RE: Declaration in accordance with Section 5 of the Planning & Development Acts 2000 (As Amended) – EX47/2025 –

DECLARATION IN ACCORDANCE WITH ARTICLE 5 (2) (A) OF THE PLANNING & DEVELOPMENT ACT 2000 AS AMENDED

Location: Russborough House, Blessington, Co. Wicklow

Exemption Query: Re-establishment & Path Improvement

Encl. 2493B_11.3_200 - Path / Trail Detail / scale 1:20 @ A3 (2copies)

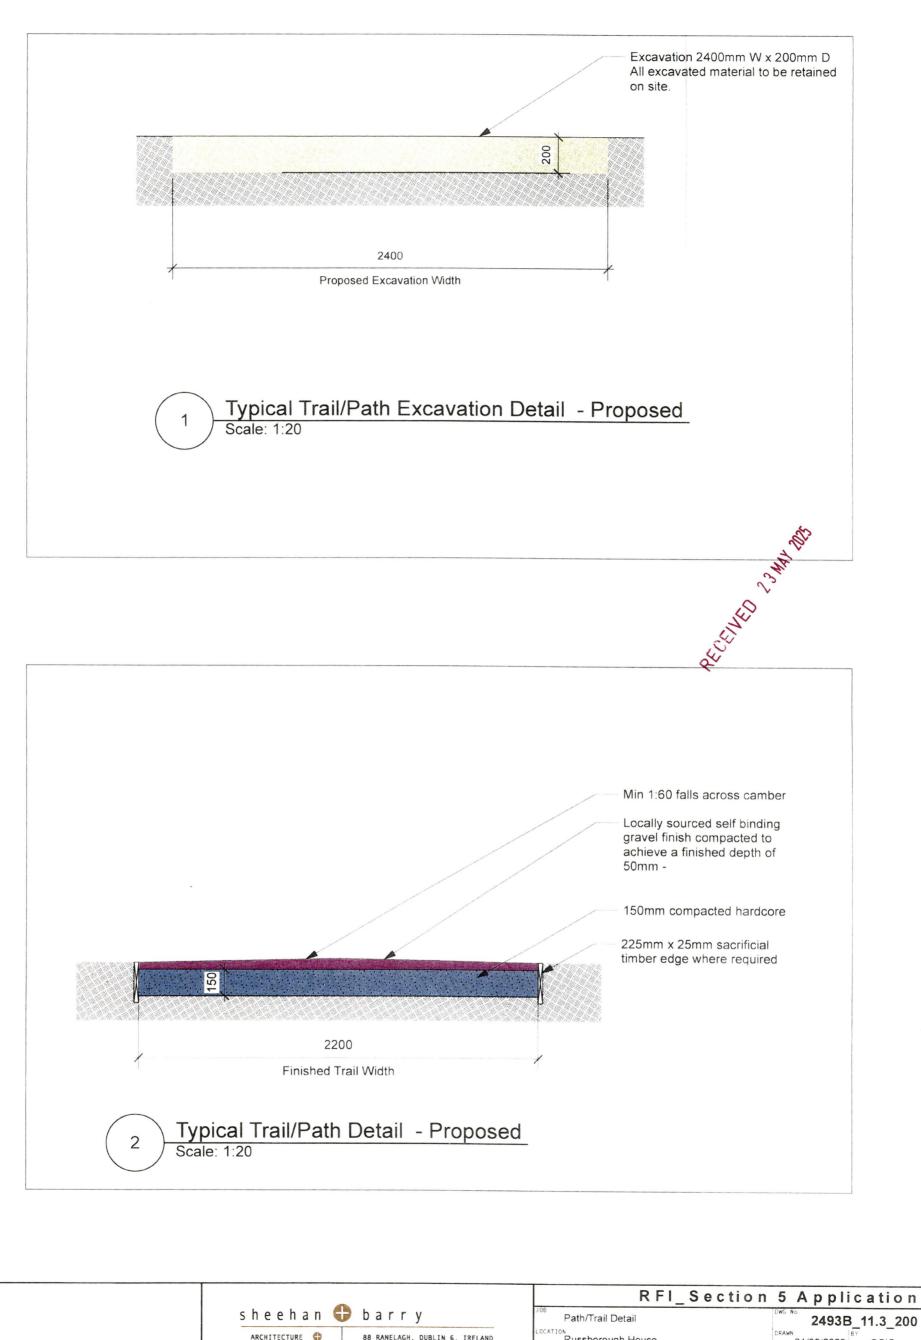
- In order to fully assess the section 5 query, you are requested to submit further
 details concerning the proposed trail consolidation and upgrade, re-establishment of
 undefined trail sections, renewal of all trail surfaces and the replacement of existing
 agricultural fencing with estate railings inclusive of;
- a) Confirmation that the proposed width of the paths will not exceed 3m.
- b) Full details regarding any site excavation required i.e. depths etc. as part of the trail works
- c) Confirmation that the replacement railings will not exceed 1.2 metres or the height of the structure being replaced, whichever is the greater, and in any event that they will not exceed 2 metres.

- Confirmation that the proposed width of the paths will not exceed 3m.
 We herewith confirm that the path widths are proposed at 2.2 metres, please refer to attached drawing 2493B_11.3_200 Path / Trail Detail / scale 1:20.
- 2. Full details regarding any site excavations required i.e. depths etc. as part of the trail works. Please refer to attached drawing 2493B_11.3_200 Path / Trail Detail / scale 1:20.
- 3. Confirmation that the replacement railings will not exceed 1.2 metres or the height of the structure being replaced, whichever is greater, and in any event that they will not exceed 2 metres.

We herewith confirm that the height of the proposed replacement railing will not exceed 1.2 metres.
